Access Compliance Report

Public Rights-of-Way

(Curb Ramps)

Intersection ID: 52448	Main Street: WOODWARD_AV	Cross Street: DOUBLE_OAKS_RD	Location: NW
ADA ID: 2065FBABBBE6	Ramp Type: Directional1	Initial Pass/Fail: Fail	Overall Compliance: No
Severity Score: 12.5			
Codes/Mitigation Info/Possible Solution		Field Measurements/Component Compliance

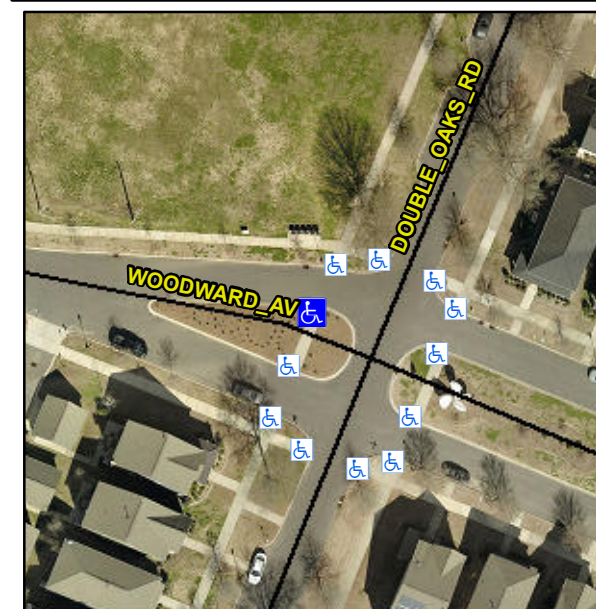
LOCATED ON MEDIAN

R304.2.2

Remove & Replace Entire Ramp.
